**RECOMMENDATION
MEETING
APRIL 27, 2015
6:30PM**

PROJECT # 3016541 4046 8TH AVE NE

PROPOSAL:

The applicant proposes one four-story residential structure containing 37 units. No on-site vehicular parking is proposed. Covered bicycle parking is proposed on the east portion of the site.

Rendered
Landscape Plan

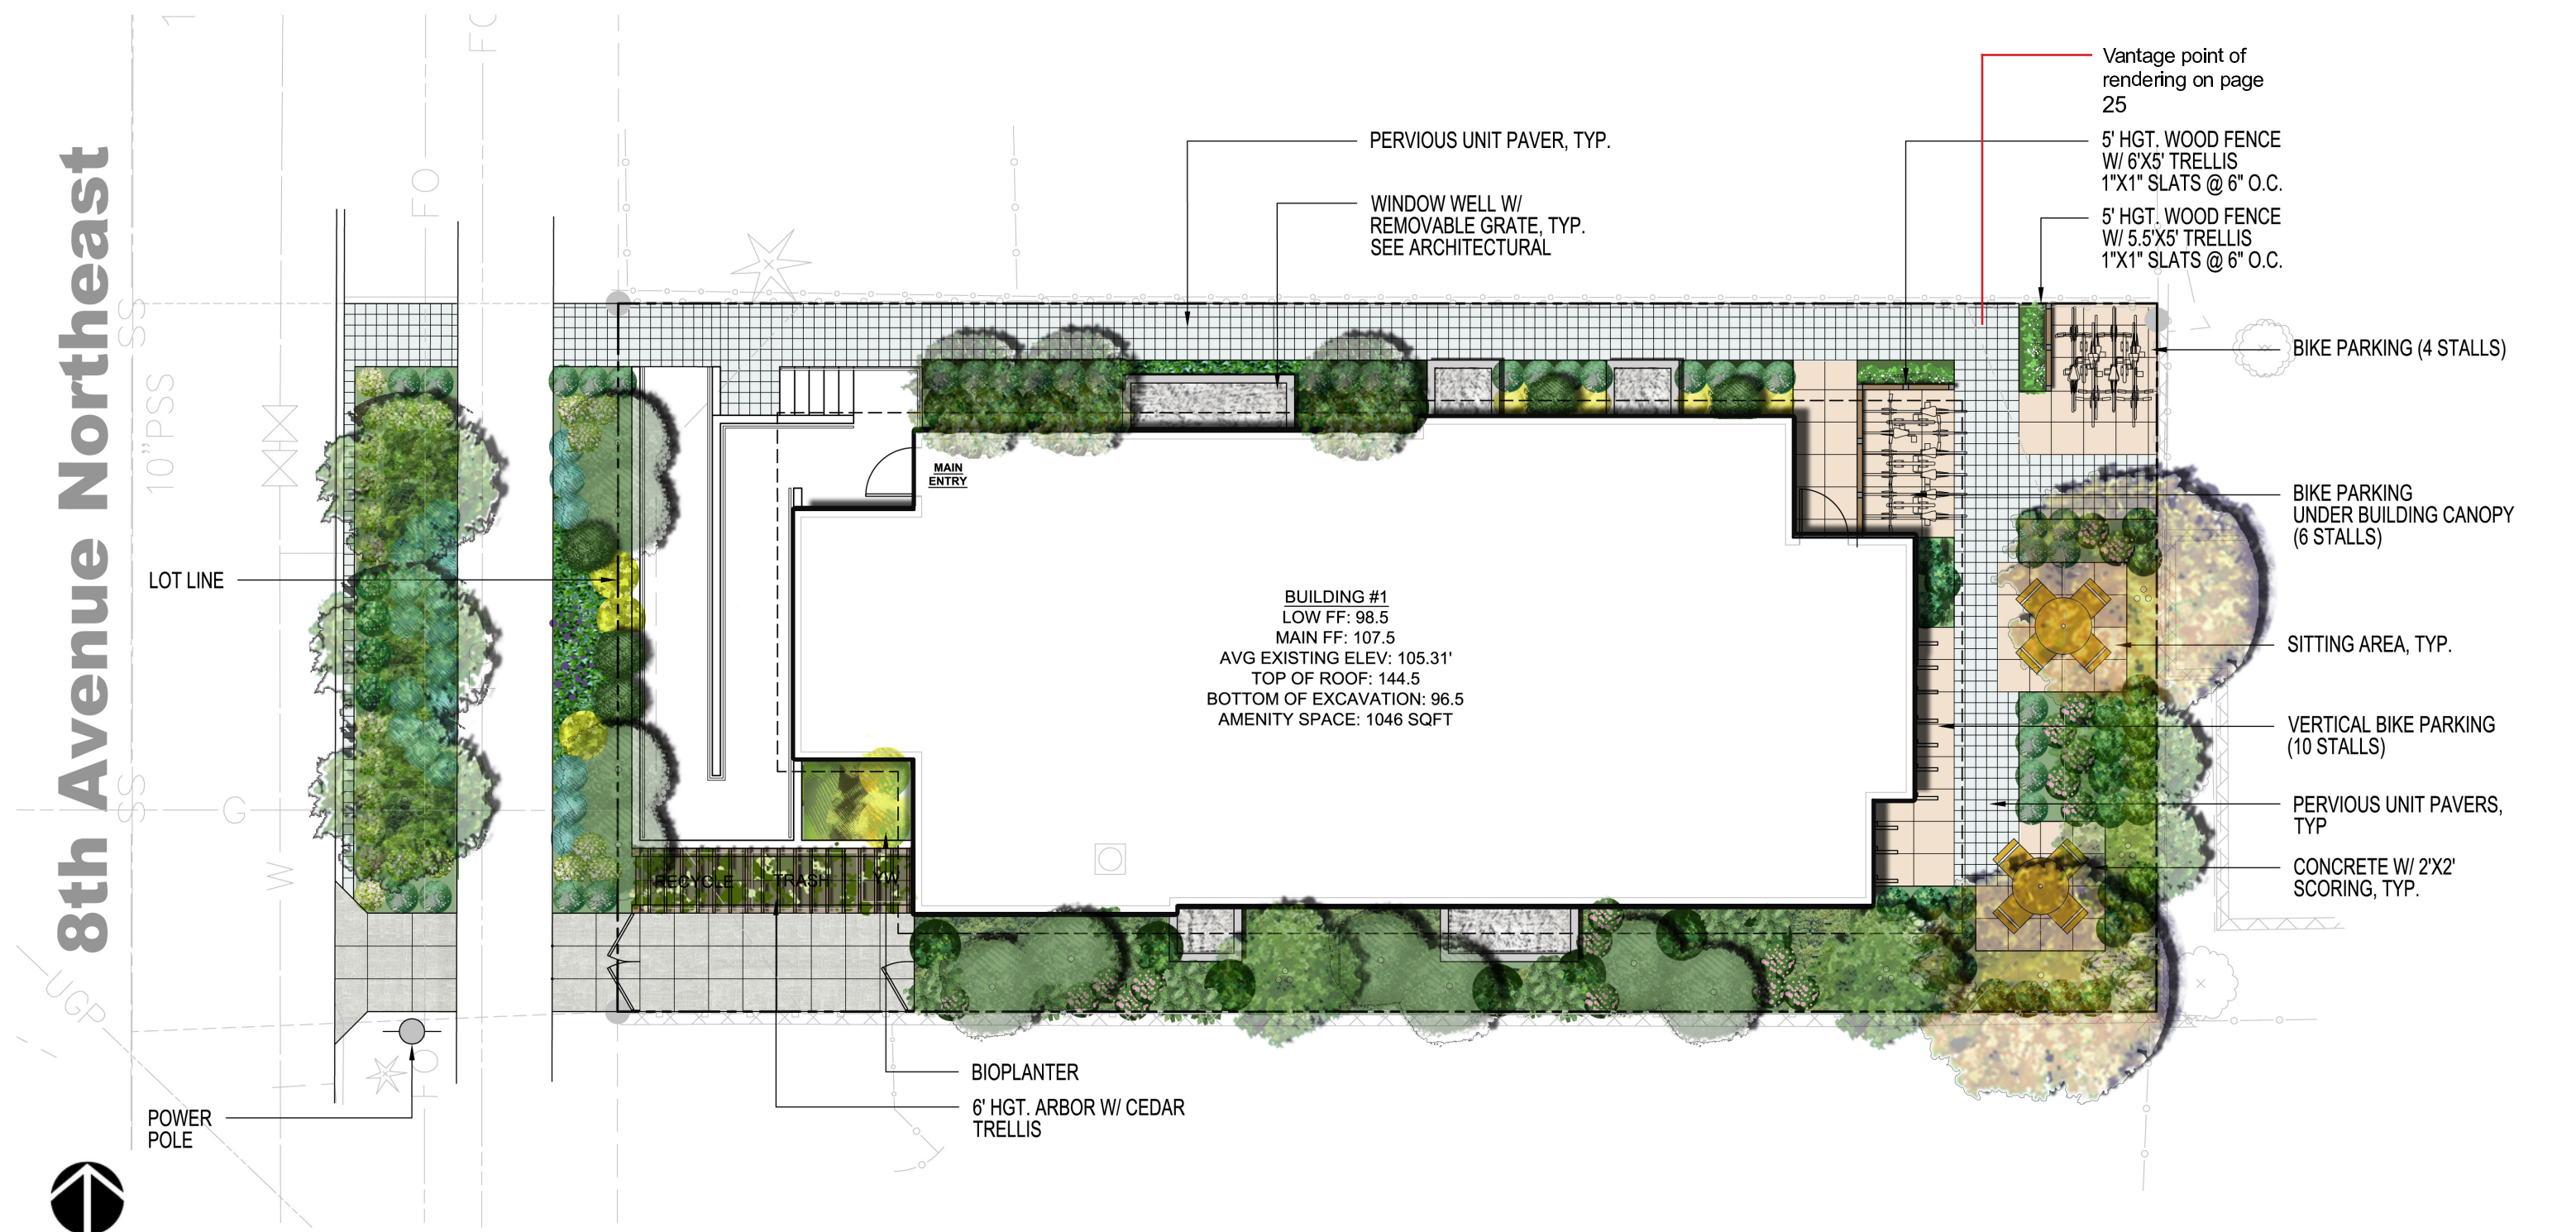
At the Early Design Guidance Meeting, the Board agreed that the consolidation of multiple open spaces into one area, as proposed in Option 3, is preferable. The Board supported the location of the courtyard, and requested more information regarding the functionality and aesthetics of the open space and how it relates to the building, bicycle parking, windows, and the property to the east.
Response: Working with Communita Design on the Landscape plan, we planned the amenity area to be functional for a large amount of bicycle parking, in addition to incorporating tables and seating for residents to enjoy. This area has also incorporated a landscape buffer for neighboring sites to reduce the impact of this area on existing buildings, and maintaining a sense of privacy for our residents

The landscape plan calls out a very detailed pattern for the pervious pavers along the pathway and amenity area. This adds a fun element to the site and helps to inform the purpose of each space for residents and guests

Building Section

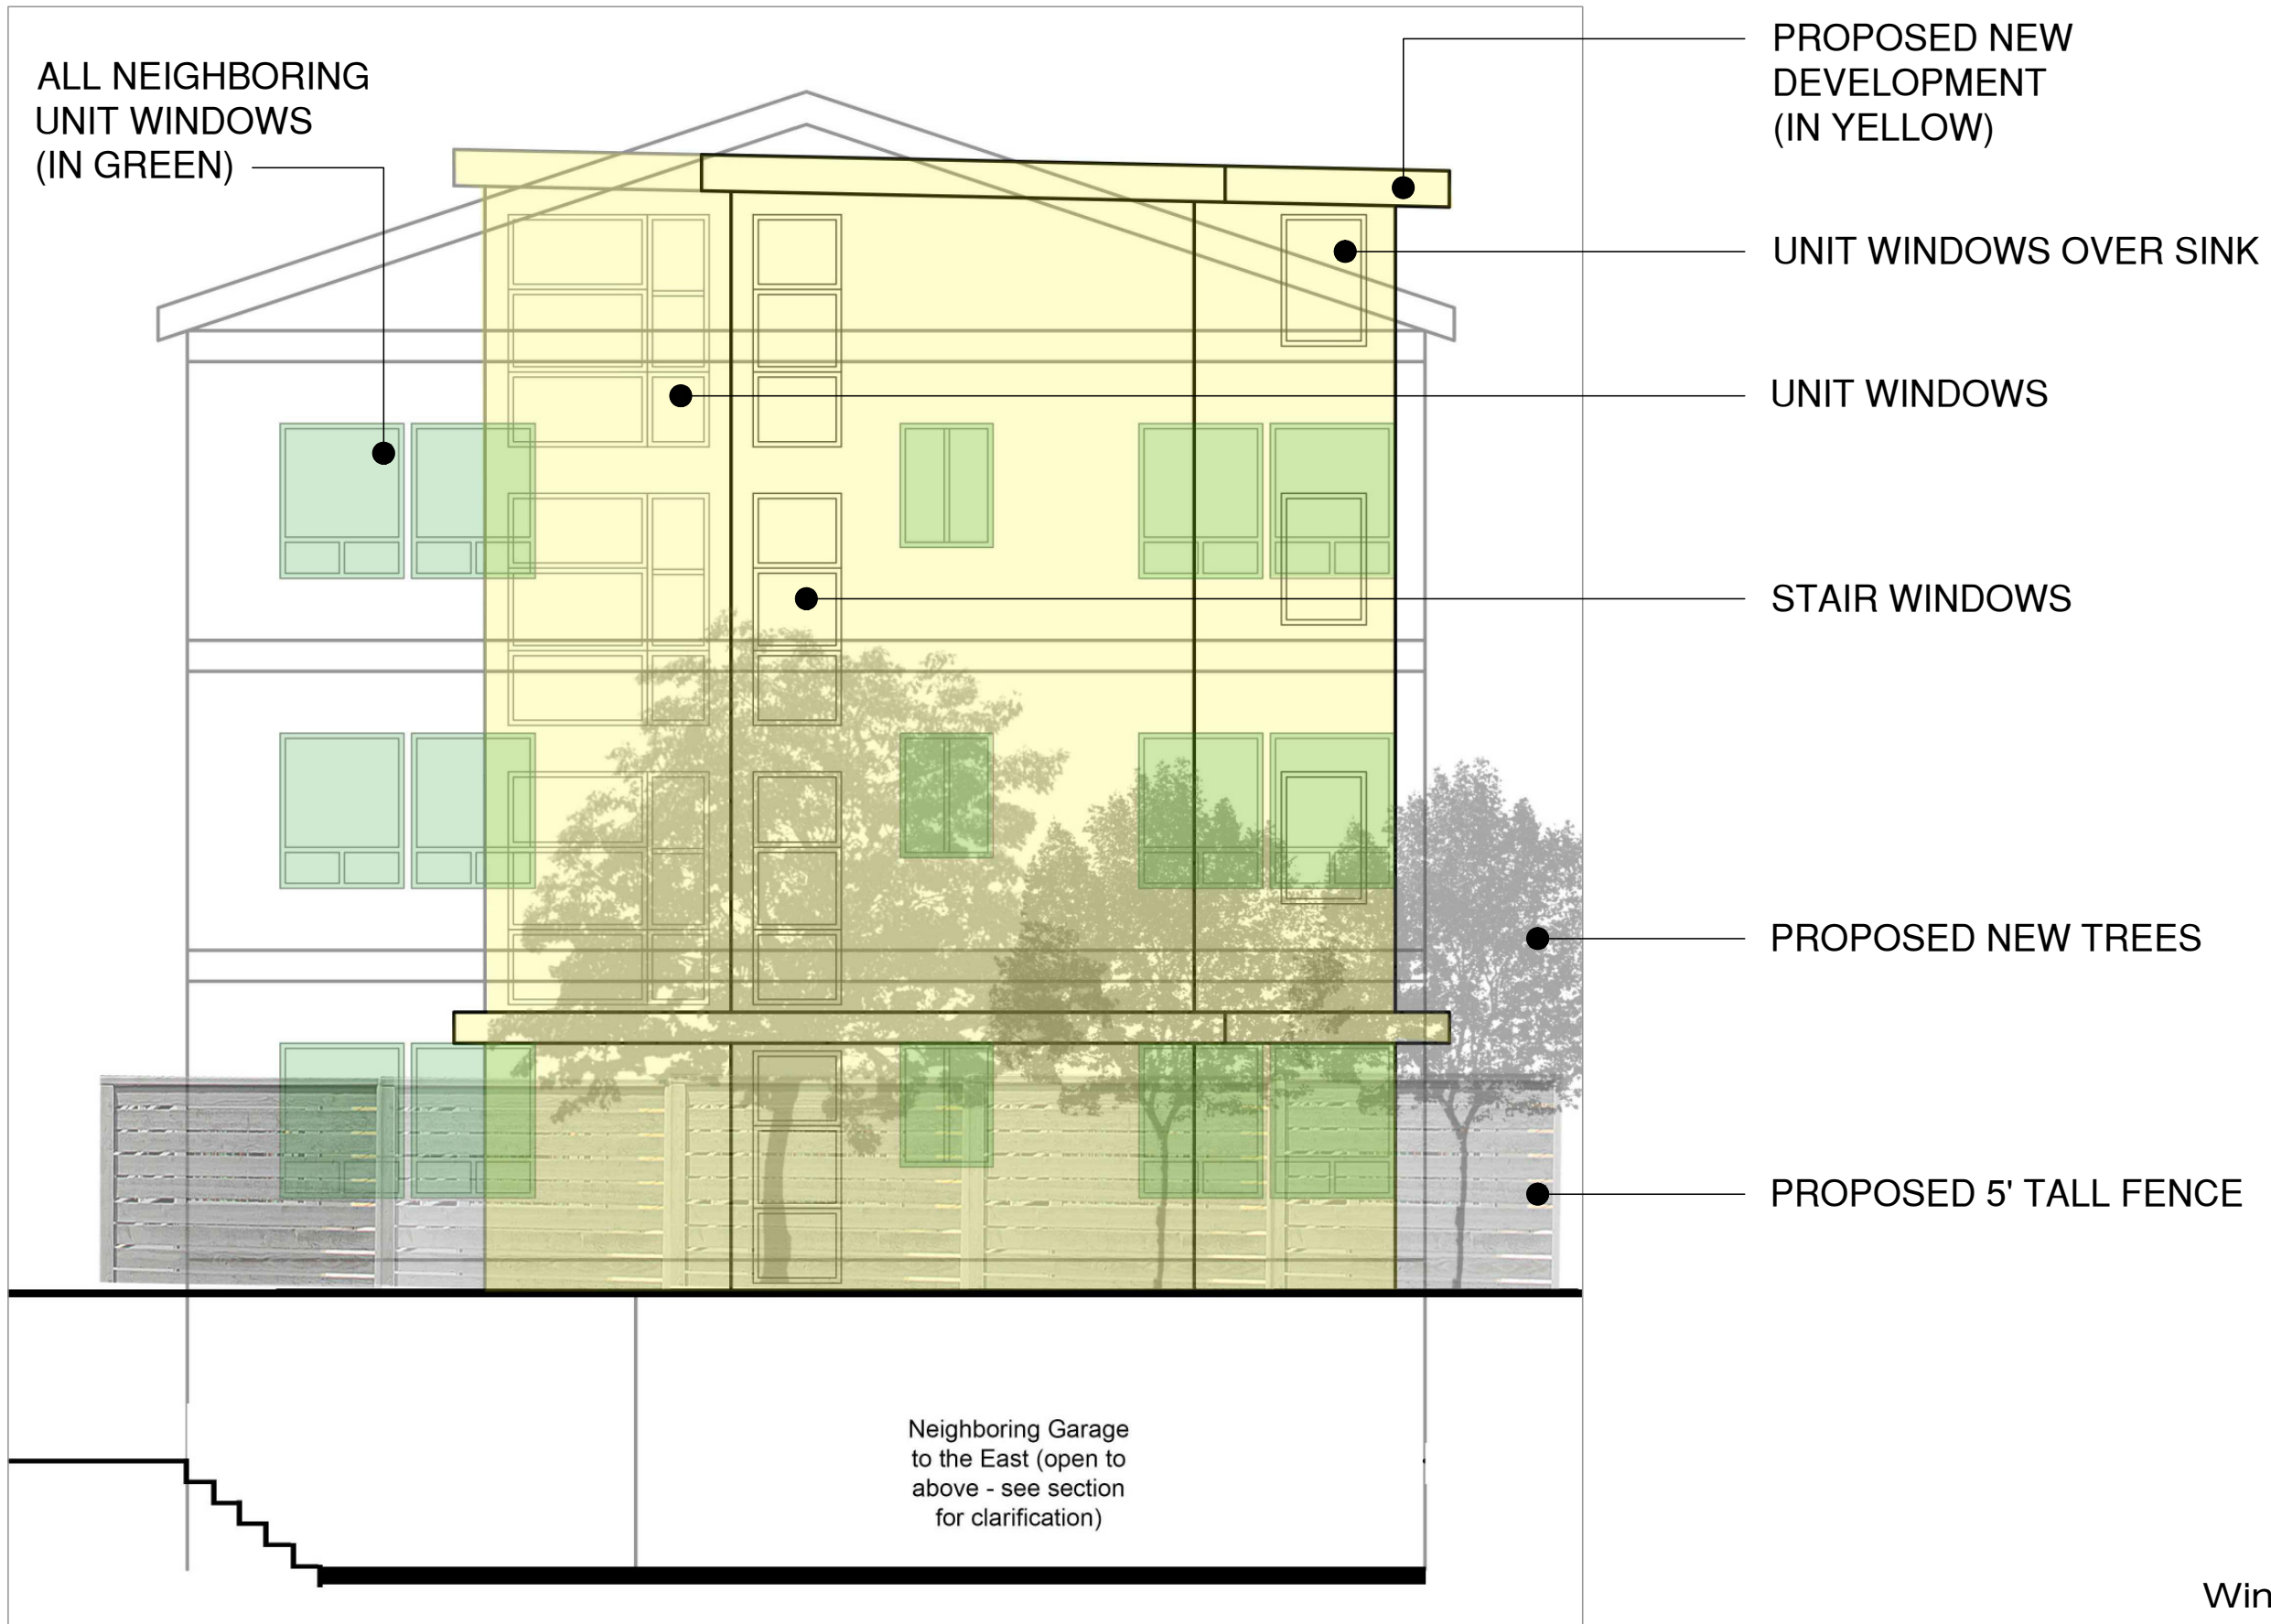
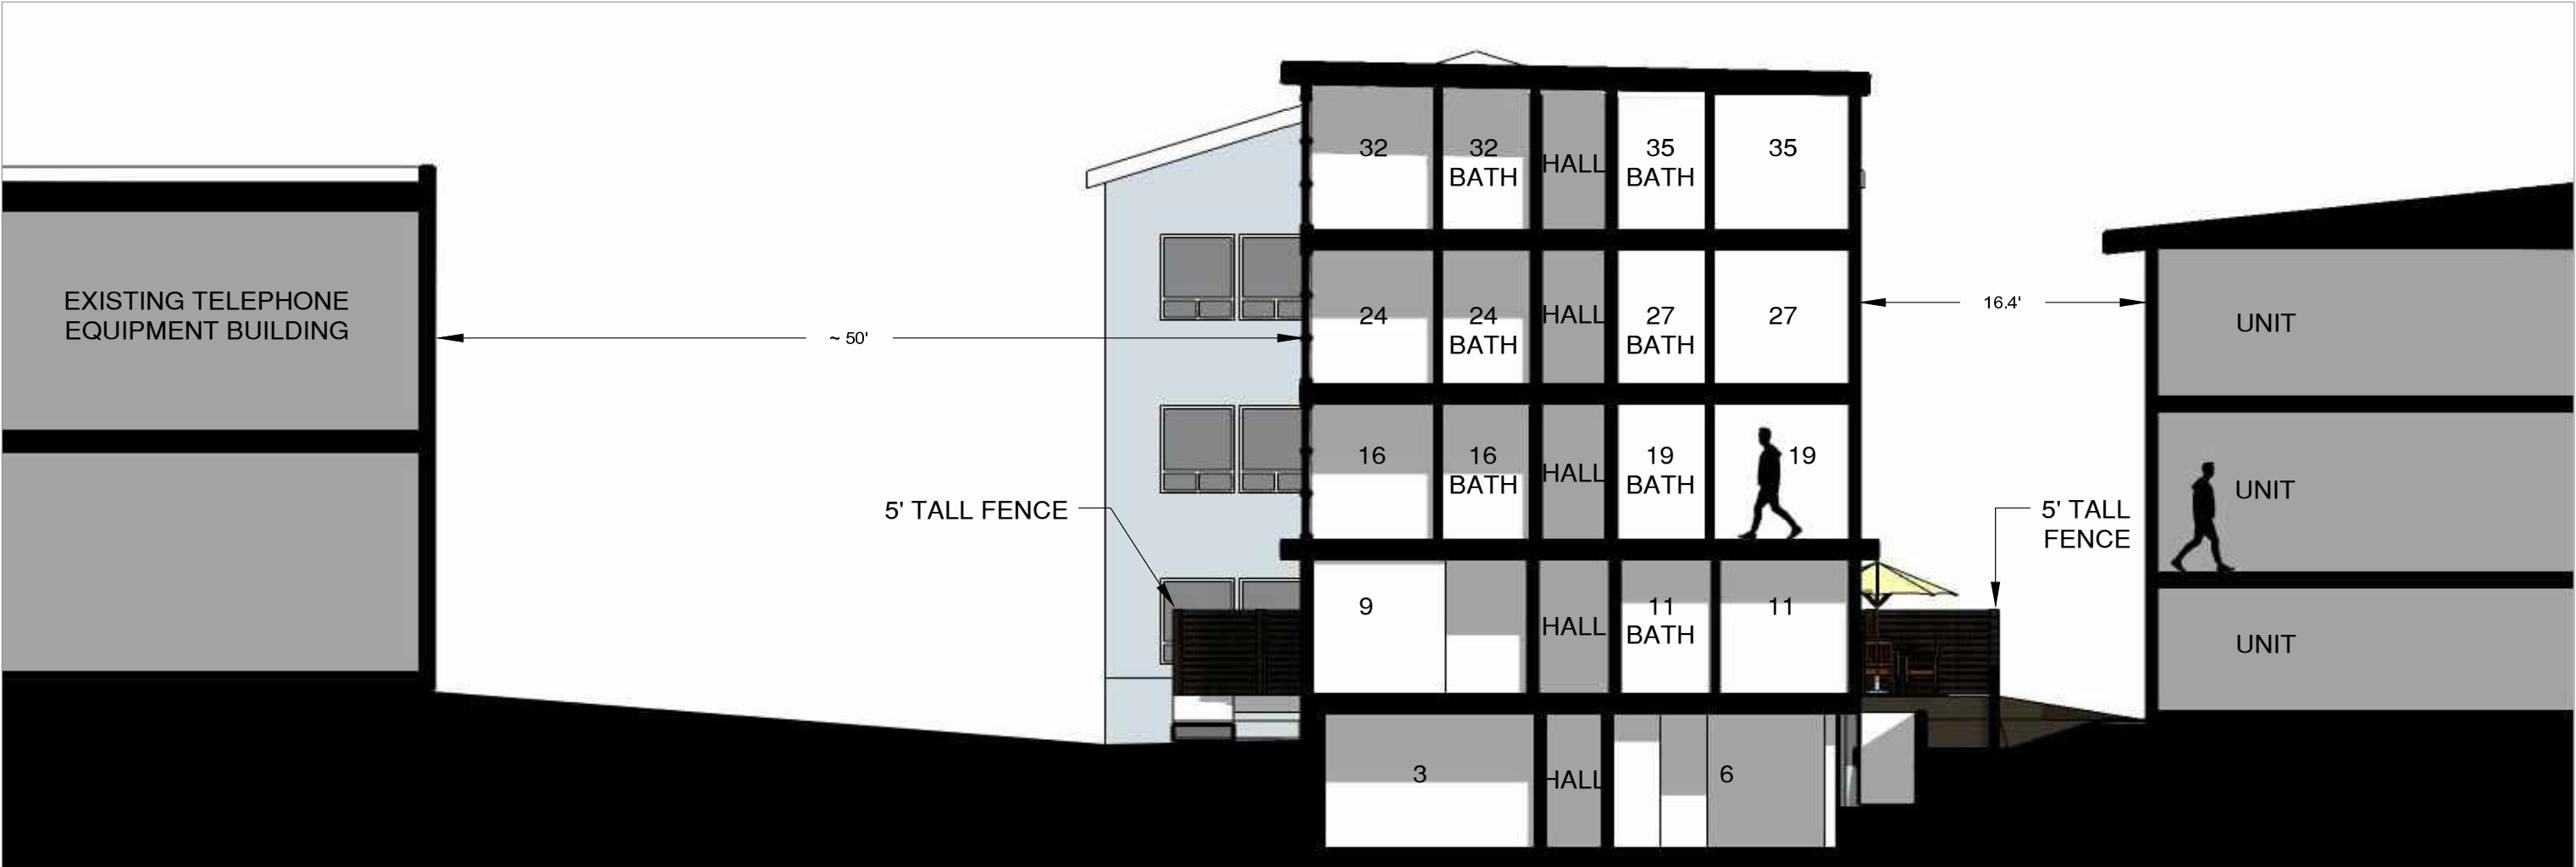
At the Early Design Guidance Meeting, the Board recommended that the design should respond to the south, and locate windows and materials to respond to the adjacent structure.

Response: We have followed the boards recommendation and brought the main entry of the building to the northwest corner, in order to utilize existing topography opposed to “fighting” it, by entering along the southwest corner. A window privacy study has been conducted (see pages 32-36), and we feel it appropriately responds to the neighboring buildings to the south and east. The majority of window overlap has been significantly reduced by a vegetation buffer.
